Access Compliance Report

Public Rights-of-Way

(Curb Ramps)

Intersection ID: 10037555	Main Street: SELWYN_AV	Cross Street: N/A	Location: SE
ADA ID: 6B74B24B697A	Ramp Type: Perp	Initial Pass/Fail: Pass	Overall Compliance: No
Codes/Mitigation Info/Possible Solution		Field Measurements/Component Compliance	
Severity Score: 7.5

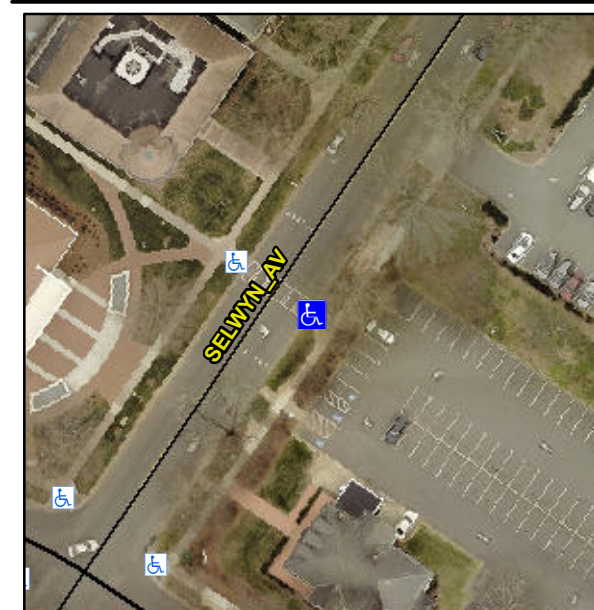
Remove & Replace Detectable Warning System. Remove & Replace Gutter.

R305.1.4, R305.2, R304.5.4
